## Starter Motor P/N 50-818445 3

### Models Affected

1998 225/250 HP, 3.0 Litre  
S/N OG594077 Thru OG638551

a - Starter Motor Part Number Label  
b - Factory Rework Marking (OK)

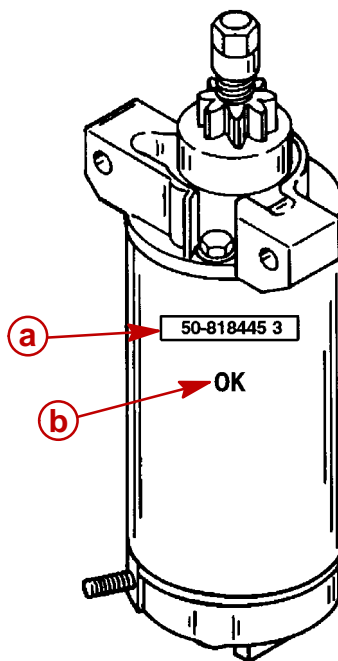
The rubber snubbers inside the starter motor housing may have been dislodged, during assembly. Lack of the correct snubber will allow the starter motor through bolts to vibrate excessively causing breakage of the bolts.

When engine is in for service, or before sale of the engine, inspect engine carton, or starter motor for having been reworked at the factory. Rework identification listed below. If engine has NOT been reworked at the factory, replace the starter motor .

**FACTORY IDENTIFICATION:** Engines reworked at the factory will have a Blue dot marked on the engine carton near the serial number location, and the white letters "OK" marked on the starter motor near the part number label.

**DEALER IDENTIFICATION:** After having replaced the starter motor, mark with white paint near the starter motor part number label the letters "OK".
